**General Bid Bulletin No. 25**  
31 August 2021

**THE MALOLOS-CLARK RAILWAY PROJECT AND THE NORTH-SOUTH RAILWAY  
PROJECT SOUTH LINE COMMUTER PACKAGE CP NS-01: PROCUREMENT OF  
ELECTRICAL AND MECHANICAL SYSTEMS AND TRACK WORKS (IFB No: 21-040-3)**

**PACKAGE CP NS-01: E&M SYSTEMS AND TRACK WORKS**  
**General Bid Bulletin No. 25**  
**Annex A**

**PACKAGE CP NS-01: E&M SYSTEMS AND TRACK WORKS**  
**General Bid Bulletin No. 25**  
**Annex B**

DATE	21 JUNE 2019
SCALE	NONE
SHEET No.	10 OF 20
DRG No.	MCRP-DWG-DEP-PDS-0010
DRG S.	-
REV	01

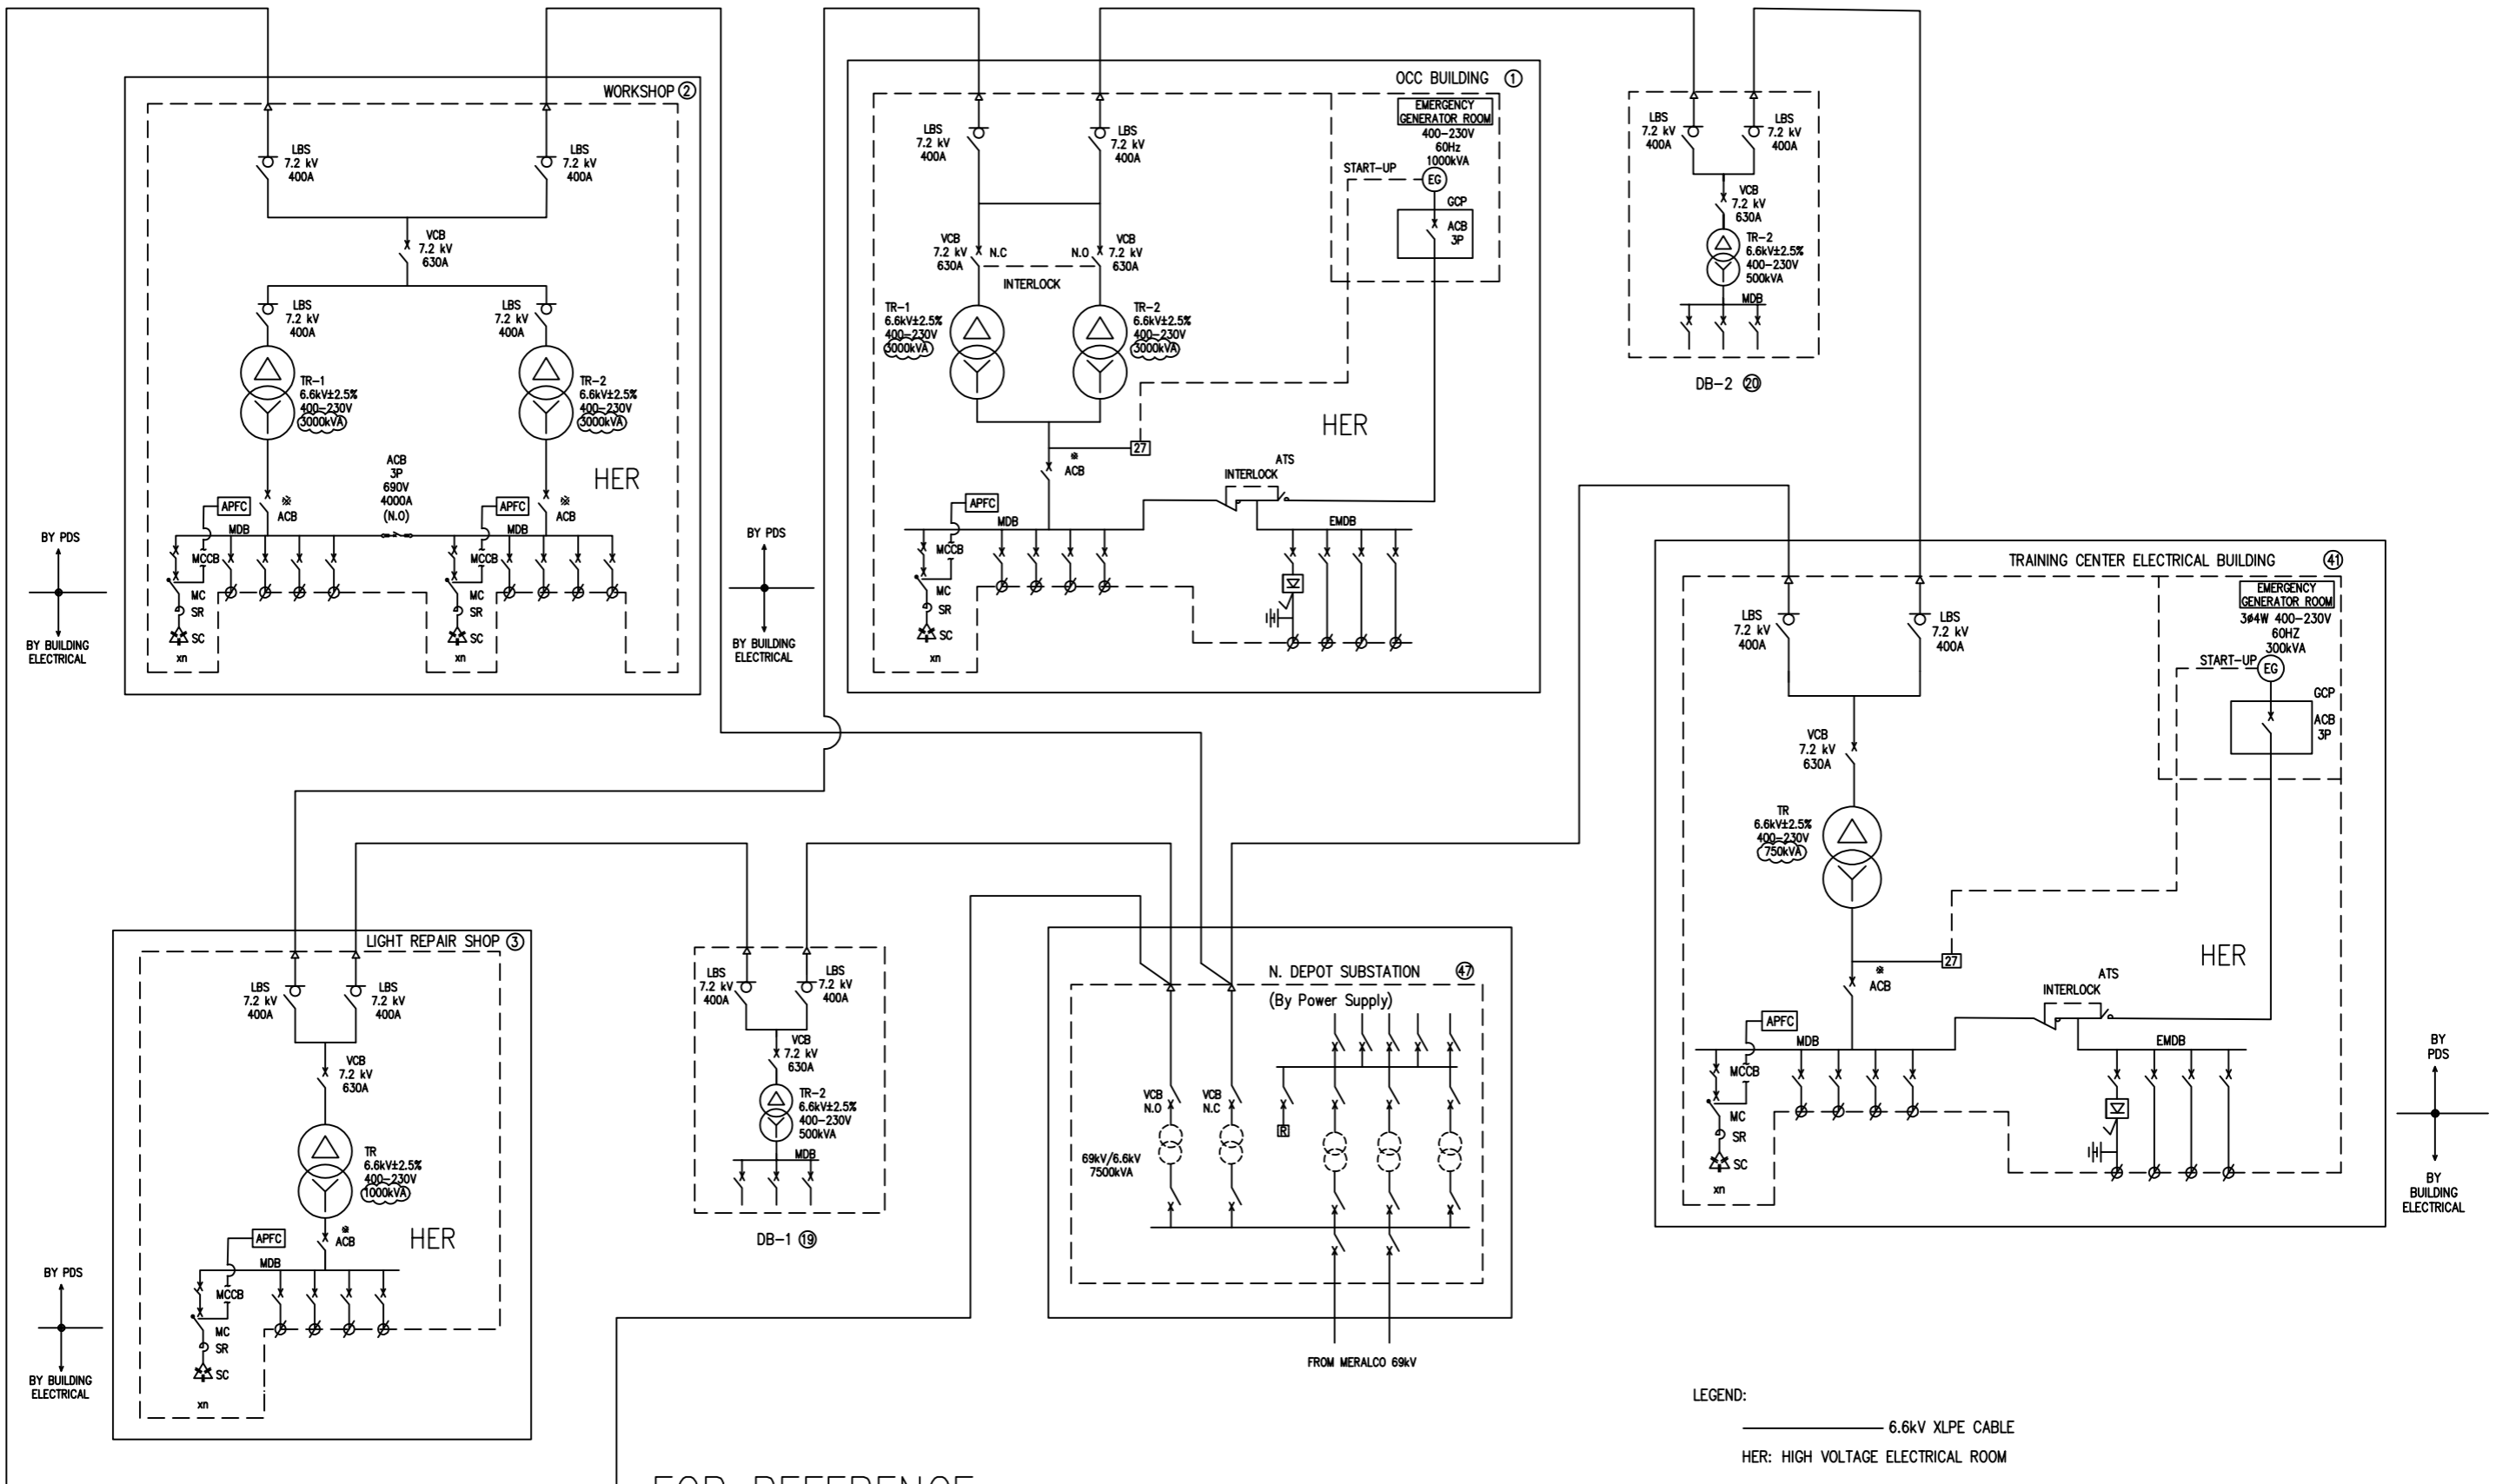
18	Part 2 Vol.3 ERD (a) page 236, MCRP-DWG-CIA-PDS-0005	Transformer sizes revised.
19	Part 2 Vol.3 ERD (a) page 237, MCRP-DWG-CIA-PDS-0006	Transformer sizes revised.
20	Part 2 Vol.3 ERD (a) page 241- MCRP-DWG-DEP-PDS-0010	Transformer sizes revised.
21	Part 2 Vol.3 ERD (a) page 242, MCRP-DWG-DEP-PDS-0011	Transformer sizes revised.
22	Part 2 Vol.3 ERD (a) page 243, MCRP-DWG-DEP-PDS-0012	Transformer sizes revised.
23	Part 2 Vol.3 ERD (a) page 244, MCRP-DWG-DEP-PDS-0013	Generator room layout revised and transformer sizes updated.
24	Part 2 Vol.3 ERD (a) page 245, MCRP-DWG-DEP-PDS-0014	Transformer size updated
25	Part 2 Vol.3 ERD (a) page 246, MCRP-DWG-DEP-PDS-0015	Transformer size updated

VERSIONS	DATE	DESCRIPTION
00	02 MAR 2021	ISSUED FOR REFERENCE
01	25 AUG 2021	TRANSFORMER SIZES REVISED

DATE	08 APRIL 2021
SCALE	NONE
SHEET No.	6 OF 25
DRG No.	NSRP-DWG-PDS-0006
DRG S.	-
REV	03

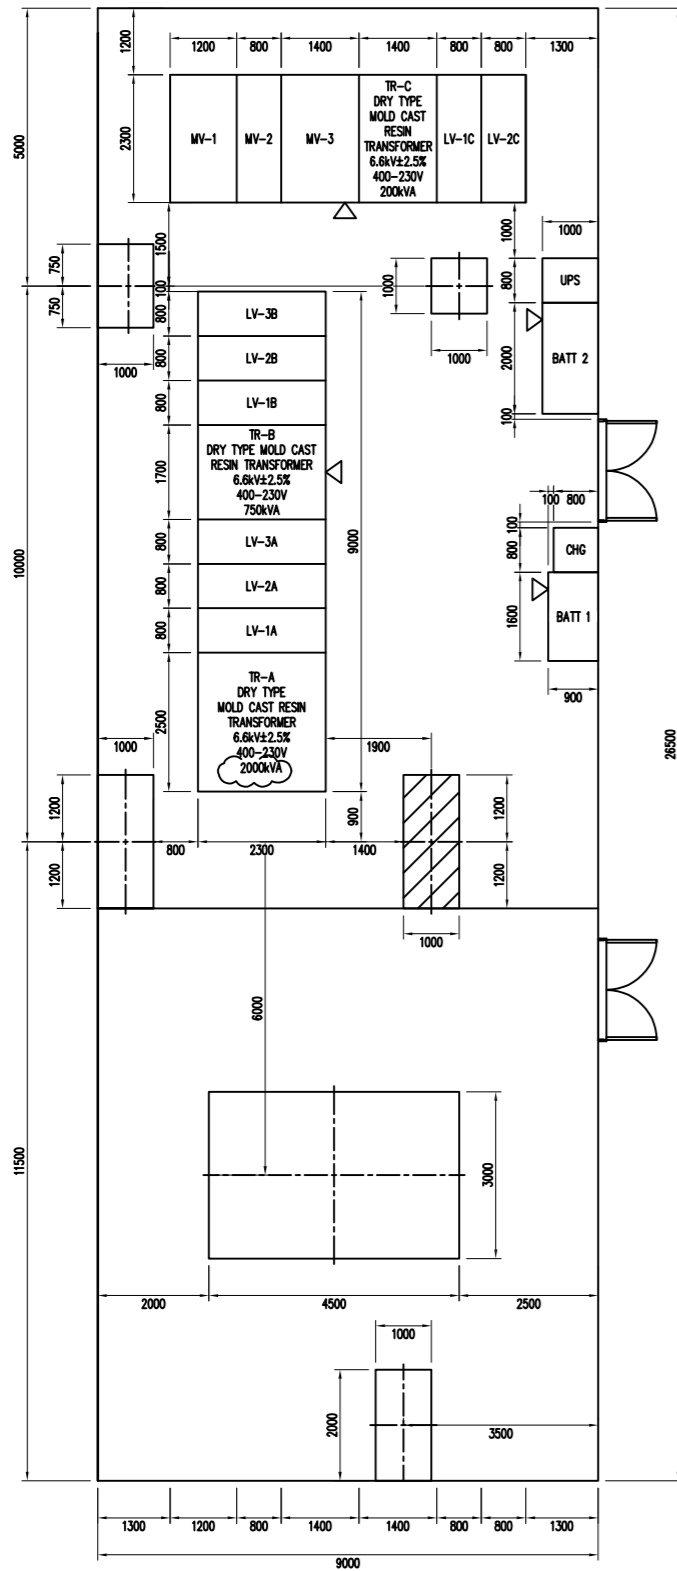
26	GBB 12 Annex B Item no.59 Page 215, NSRP-DWG-PDS-0006	Transformer sizes revised.
27	GBB 12 Annex B Item no.59 Page 216, NSRP-DWG-BLU-PDS-0007	Transformer sizes revised.
28	GBB 12 Annex B Item no.59 Page 217, NSRP-DWG-FTI-PDS-0008	Transformer size revised.
29	GBB 12 Annex B Item no.59 Page 218, NSRP-DWG-BIC-PDS-0009	Transformer sizes revised.
30	GBB 12 Annex B Item no.59 Page 219, NSRP-DWG-SUC-PDS-0010	Transformer size revised.
31	GBB 12 Annex B Item no.59 Page 224, NSRP-DWG-DEP-PDS-0015	Transformer sizes revised.
32	GBB 12 Annex B Item no.59 Page 225, NSRP-DWG-DEP-PDS-0016	Transformer sizes revised.
33	GBB 12 Annex B Item no.59 Page 226, NSRP-DWG-DEP-PDS-0017	Transformer sizes revised.

VERSIONS	DATE	DESCRIPTION
01	25 MAY 2021	GENERAL UPDATE
02	24 JUNE 2021	SANTA ROSA STATION REVISED & SS NO.18 CHAINAGE REVISED
03	25 AUG 2021	TRANSFORMER SIZE REVISED
